CLAREMONT BUSINESS PARK FILING NO. 3

GRADING AND EROSION CONTROL PLAN

El Paso County PCD File No.: EGP-20-004

GRADING & EROSION CONTROL PLAN
CLAREMONT BUSINESS PARK FIL. NO. 3
JOB NO. 44-037
DATE PREPARED: APRIL 28, 2020
DATE REVISED: JUNE 29, 2020

GRADING AND EROSION CONTROL PLAN

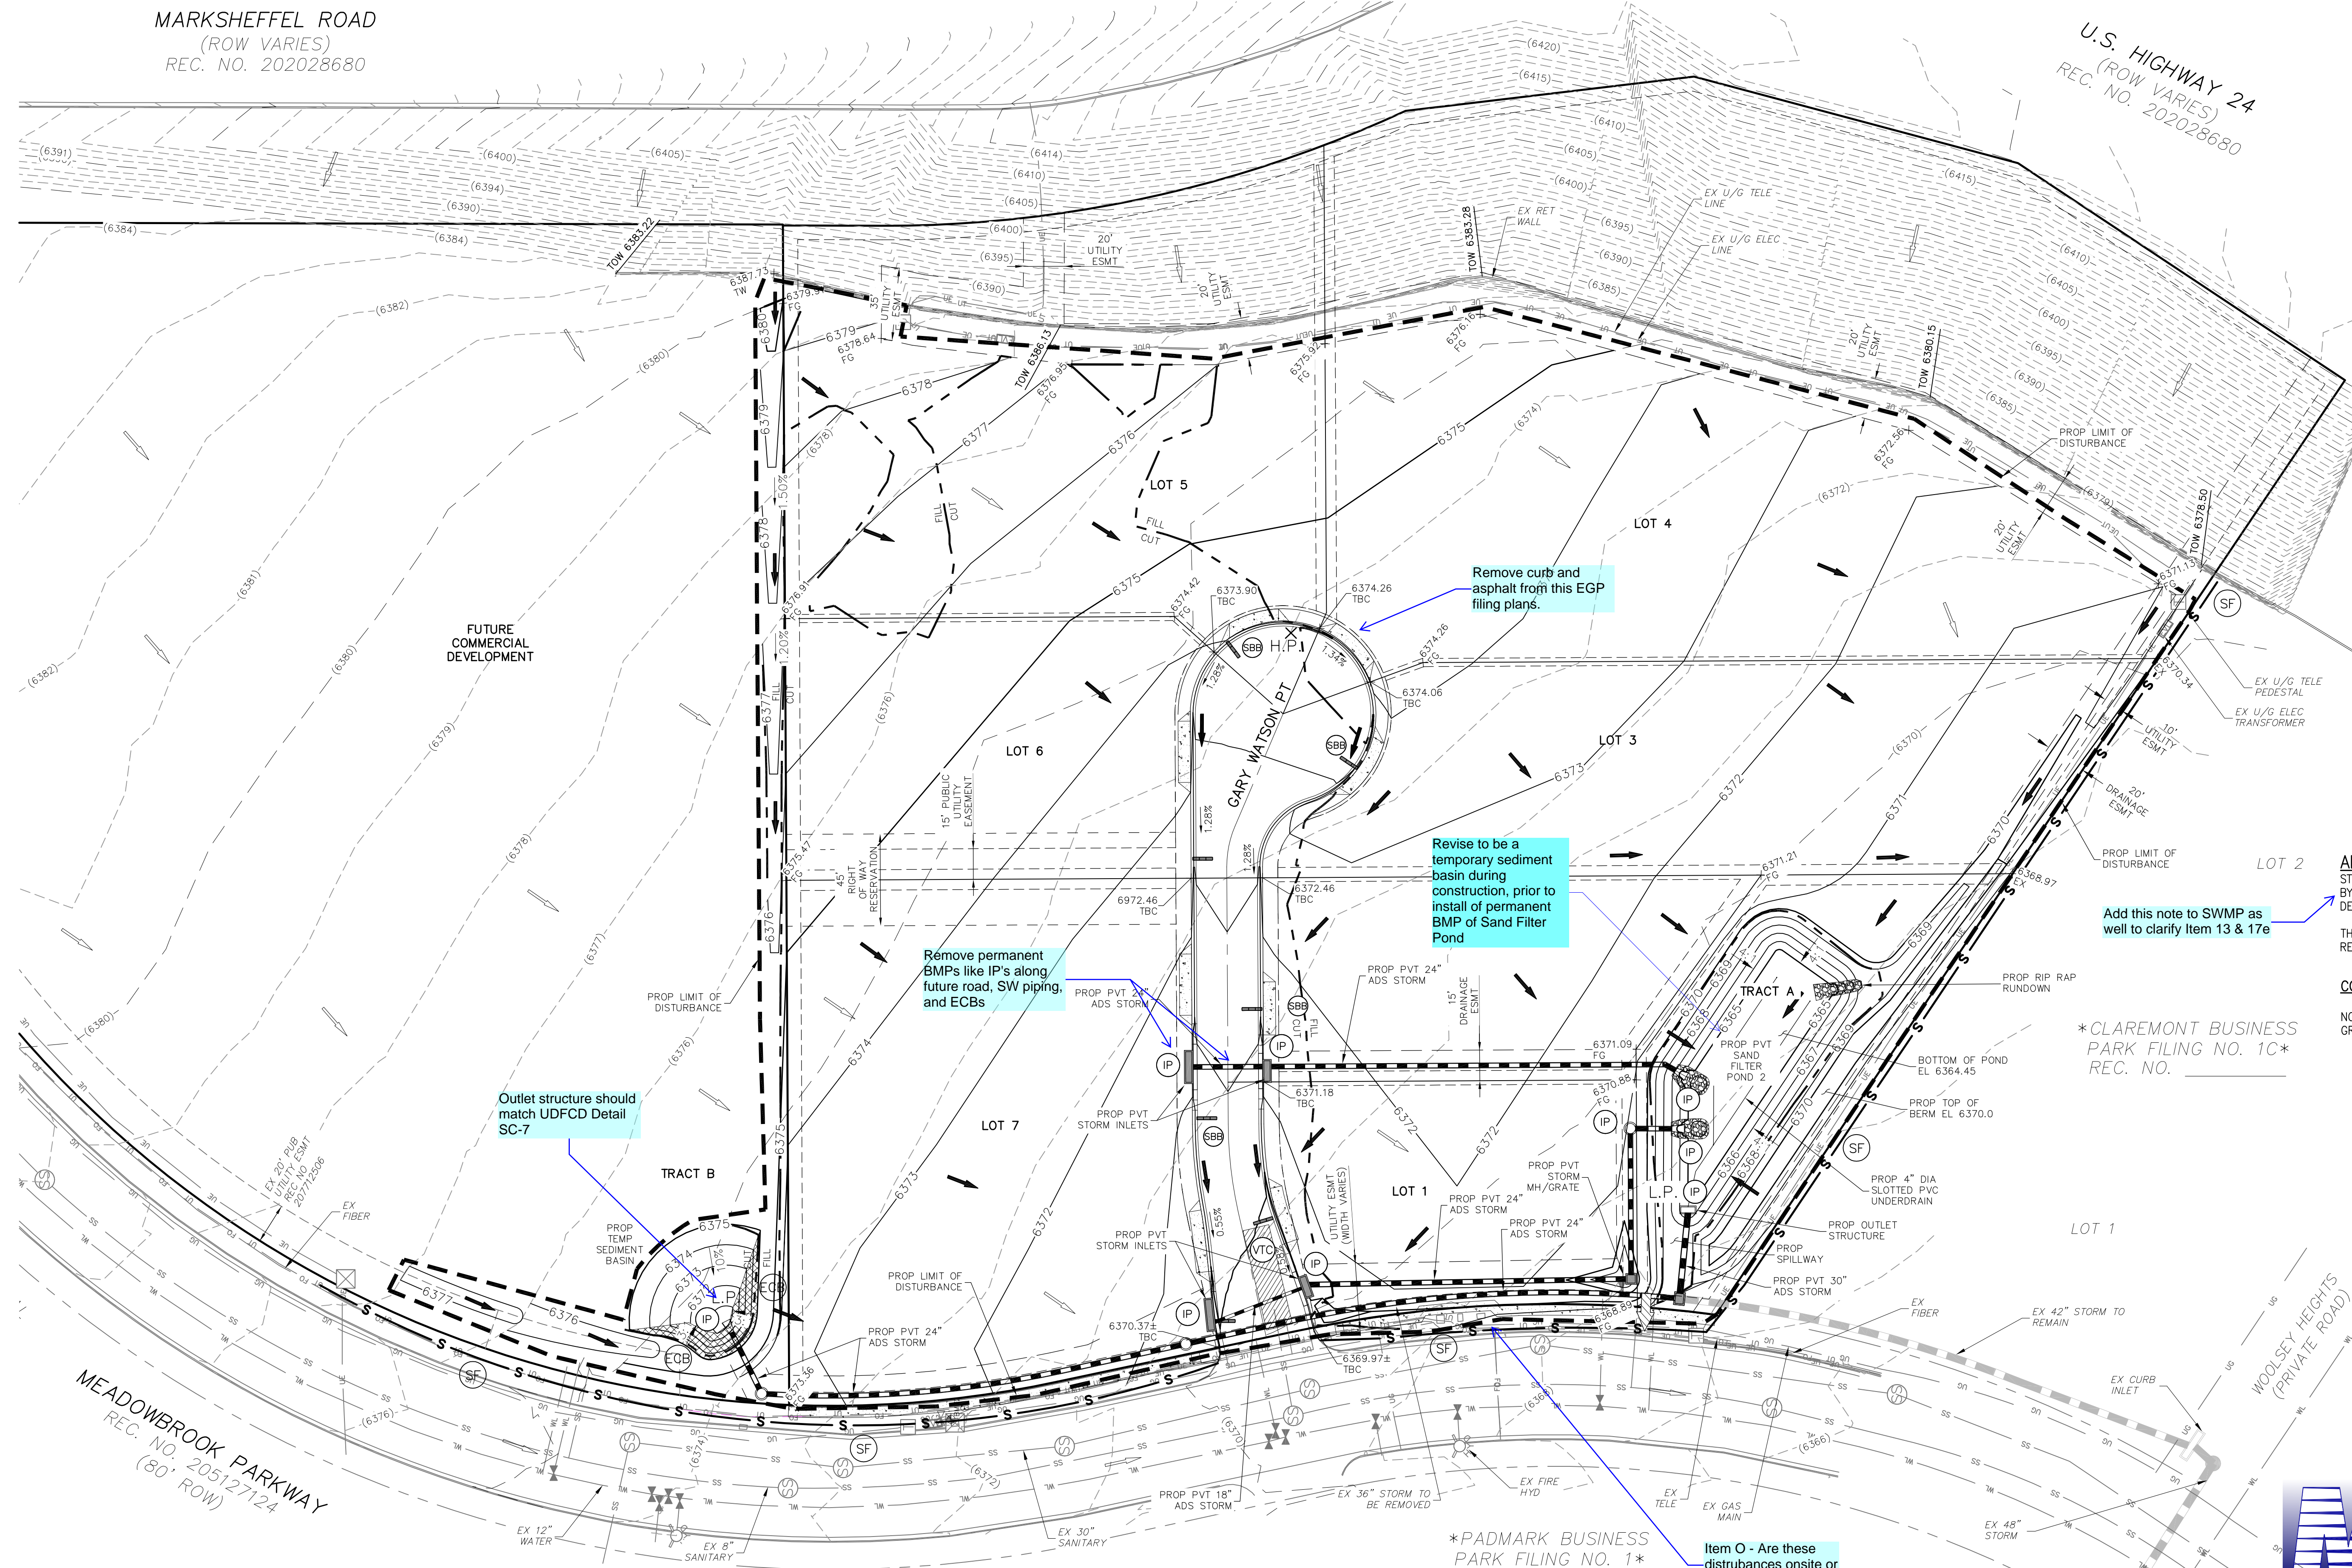
Item 17a & 17c - if same as Construction Site Boundaries, label as such

Item E - Show property lines on Legend and Plan

Item EE - Show easement linetype on Legend

GRADING & EROSION CONTROL PLAN DETAILS
CLAREMONT BUSINESS PARK FILING NO. 3
JOB NO. 44-037
DATE PREPARED: APRIL 28, 2020
DATE REVISED:

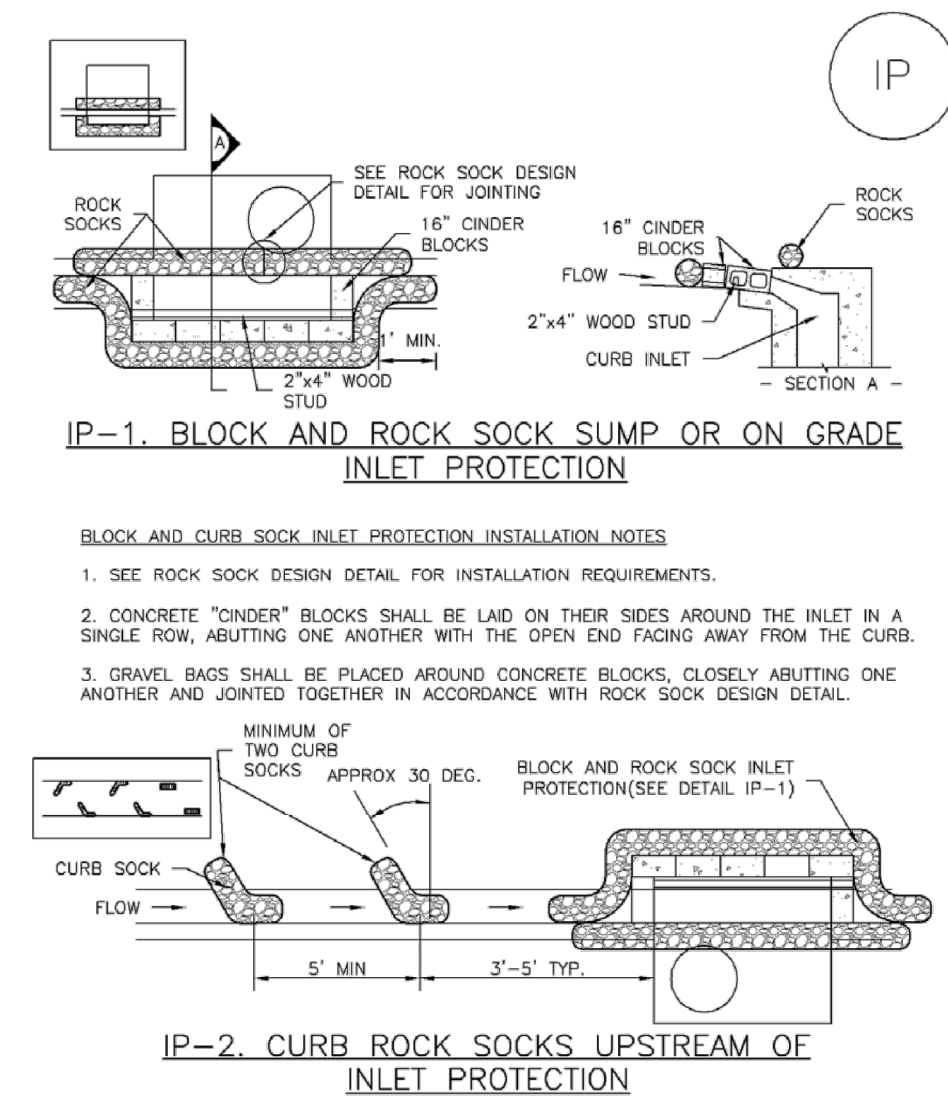
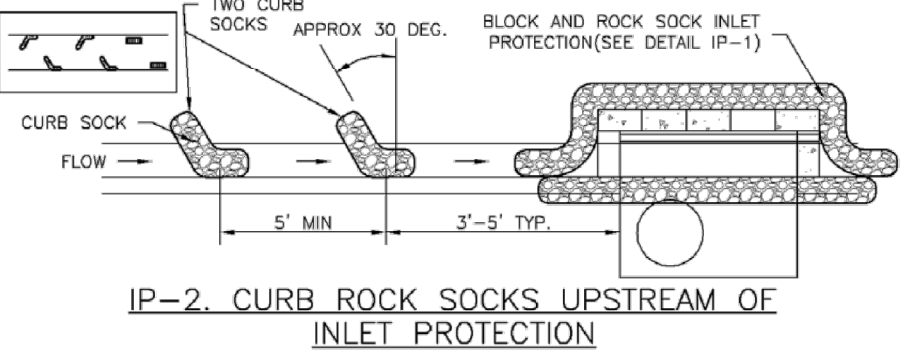
Item 20 & Z - Add details for:
- Straw Bale Checks
- Temp Sediment Basin
